**HUGHES
SERVICE INFORMATION
NOTICE**

NOTICE NO. HN-90

SUBJECT: FIELD MODIFICATION - DOOR LATCH KIT, PN M50440

MODELS AFFECTED: Model 369HS Helicopter Serial No. 0201S thru 0750S; 0761S
Model 369HM Helicopter Serial No. 0201M and subsequent

Figure 1. Modification of Door Latch Assembly, Kit No. M50440

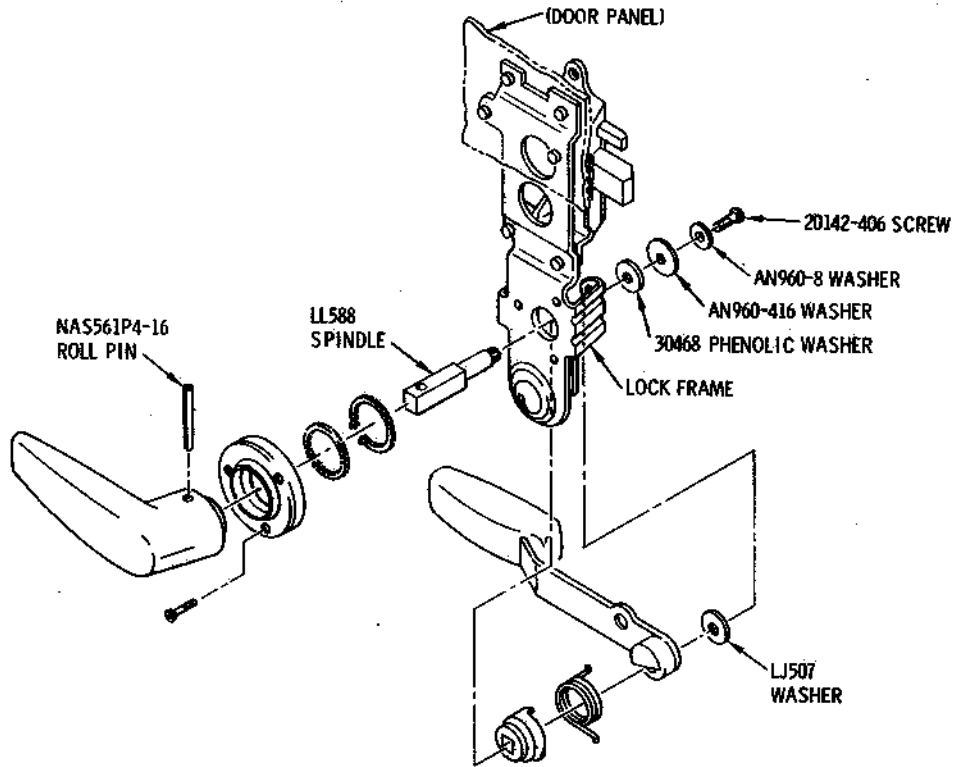
PREFACE: A modified door latch shaft is now available for installation on the above affected helicopters. The latch assembly features a revised spindle and handle retention method. This Service Information Notice provides instructions for installation of the modification kit.

- e. Insert new spindle from outer side of door through lock frame, and assemble inside door handle with new washer in lock frame, as shown in Figure 1. Secure inside door handle and spindle with new washers and screw as shown. Tighten screw sufficiently to bottom out; do not over-torque screw.
